Project	IEEE 802.16 Broadband Wireless Access Working Group <http://ieee802.org/16>	
Title	Complementary document for draft comments	
Date Submitted	2003-09-01	
Source(s)	Yossi Segal Itzik Kitroser Yigal Leiba Zion Hadad Runcom Technologies Ltd. 2 Hachoma St. 75655 Rishon Lezion, Israel	Voice: +972-3-9528440 Fax: +972-3-9528805 yossis@runcom.co.il itzikk@runcom.co.il yigall@runcom.co.il zionh@runcom.co.il
Avi Freedman	Hexagon System Engineering 21c Yegi'a Kapa'im st. P.O. Box 10149 Petach Tikva, 49001 Israel	Voice: +972-3-9224420 Fax: +972-3-9224396 avi@hexagonltd.com
Re:	Contribution elaborating on comments for letter ballot #11b	
Abstract	This document includes text referenced in several comments given for ballot 11b	
Purpose	To be integrated into P802.16d/D3 2003 draft document	
Notice	This document has been prepared to assist IEEE 802.16. It is offered as a basis for discussion and is not binding on the contributing individual(s) or organization(s). The material in this document is subject to change in form and content after further study. The contributor(s) reserve(s) the right to add, amend or withdraw material contained herein.

Complementary document for ballot 11b comments

8.5.4.2 PMP frame structure

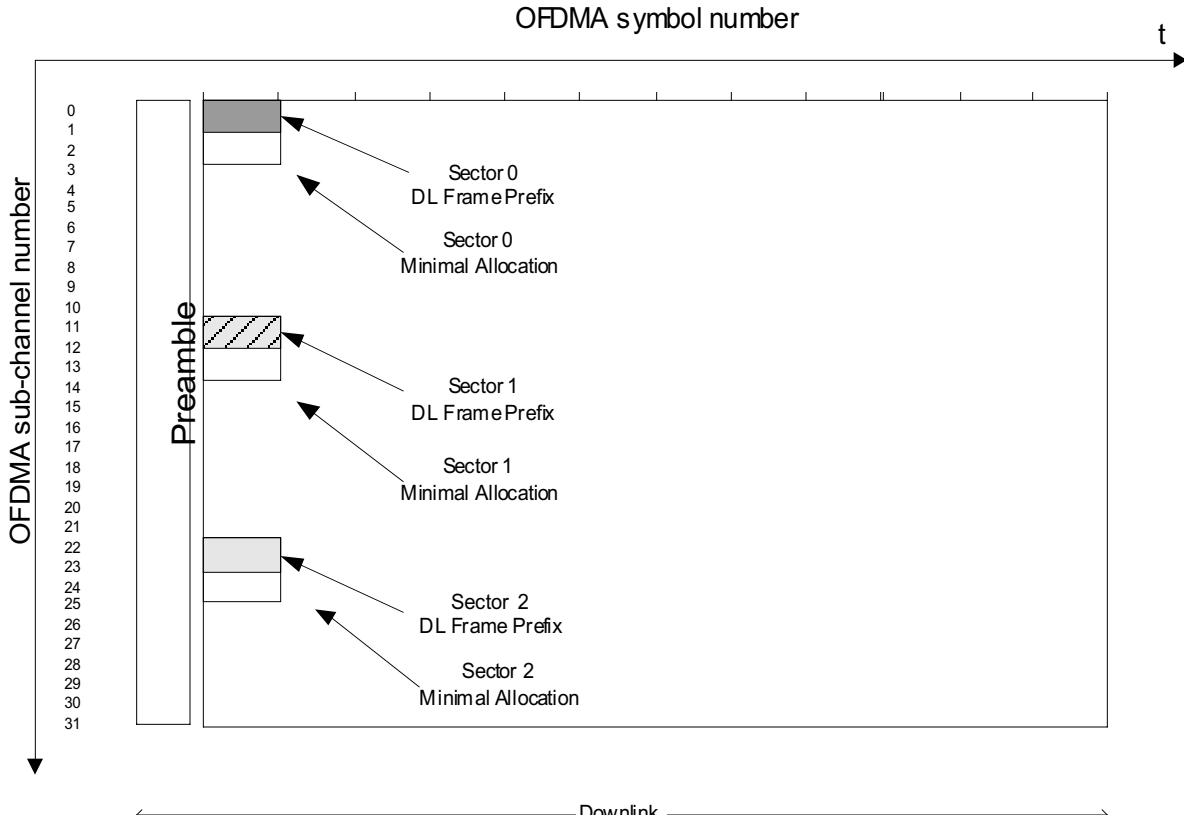
Change figure 204 to reflect allocation of 4 Sub-Channels per cell:

The first four transmitted sub-channels in the first data symbol of the DL contain the FCH and the beginning of the OFDMA DL MAP. These Sub-Channels are transmitted using QPSK rate 1/2 with the mandatory coding scheme, these Sub-Channels are also transmitted using repetition code (transmitting the same data onto two physical Sub-Channels) this will allow to transmit the data of two Sub-Channels only on the first Four Sub-Channels (the rest of the OFDMA DL MAP is also transmitted in the same way, the length of it is sent in the FCH), the repetition code is transmitted onto two adjunct Sub-Channels.

Figure 215a—DL Frame Prefix sub-channel allocation for the combined operation of STC and non-STC transmission

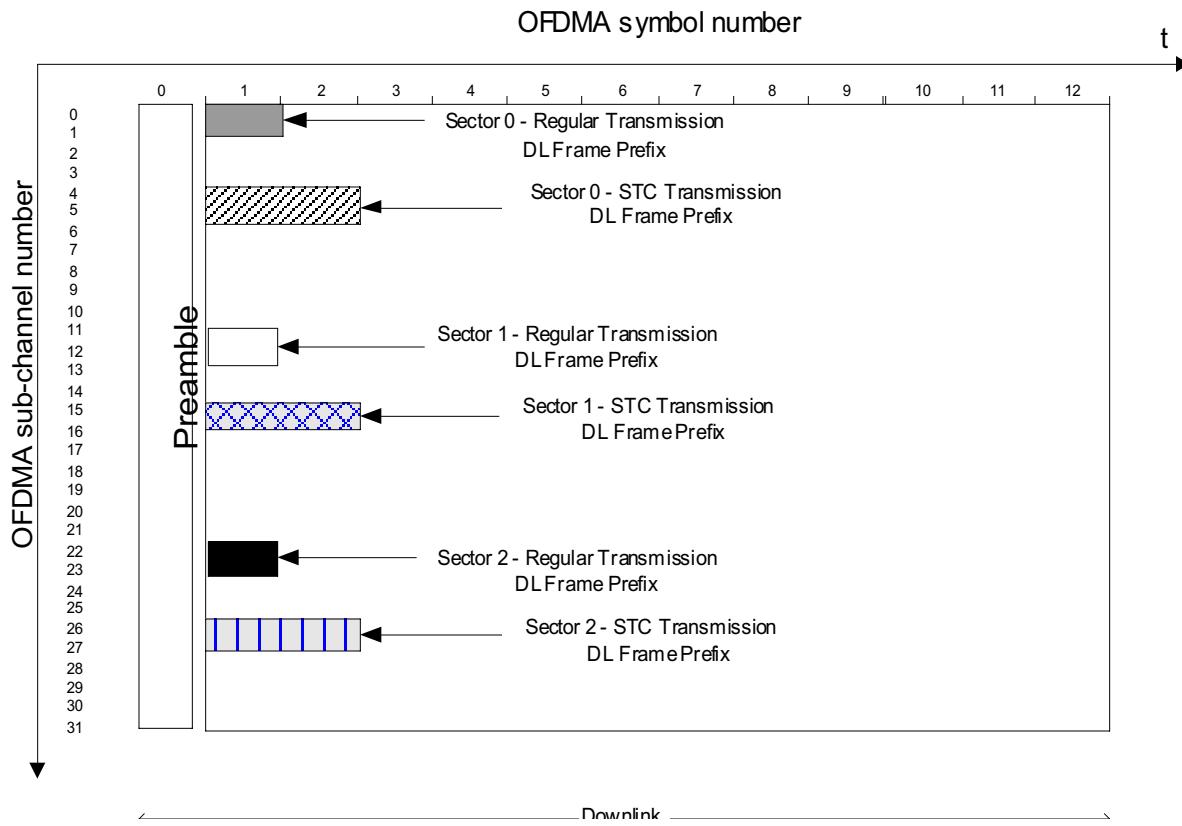
The downlink shall enable the co-transmission of regular Sub-Channel transmission and STC Sub-Channel transmission as explained in 8.5.8. The minimal allocation of sub-channels for a sector (if the sector is used) is 4 sub-channels. The first two transmitted sub-channels in the first data symbol of the DL containing the FCH as defined in 8.5.4.2, this transmission is performed using the repetition code by sending the same information on each sub-channel. For sector 0 Sub-channels 4-7 are used as the basic allocated Sub-Channels, for Sector 1 Sub-channels 15-18, for sector 2 Sub-channels 26-29.

In the following figure the structure of the DL Frame-Prefix Sub-Channel allocation (for the combined operation of STC and regular transmission) is shown:

Figure XXX.YY— Channel Coding Process for regular and repetition coding transmission

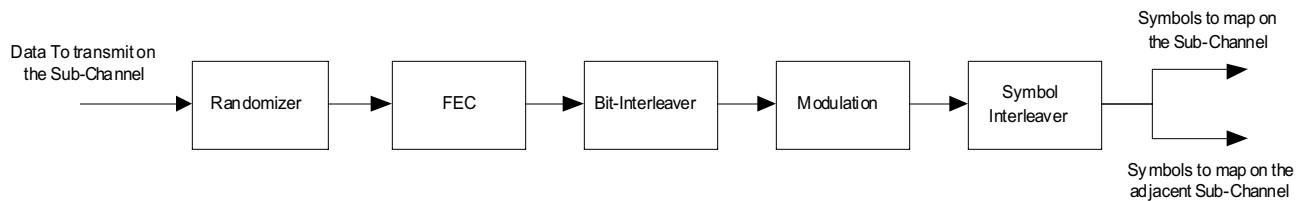
When repetition code is to transmit, allocation for the transmission shall always include an even number of adjacent Sub-Channels. The first Sub-Channel shall set the randomization seed used in section 8.5.9.1, and the data shall follow the coding chain up to the symbol interleaving. The data outputted from the modulation (section 8.5.9.4) shall be mapped onto the two consecutive allocated Sub-Channels, the process of regular encoding and repetition encoding is shown in figure XXX.YY
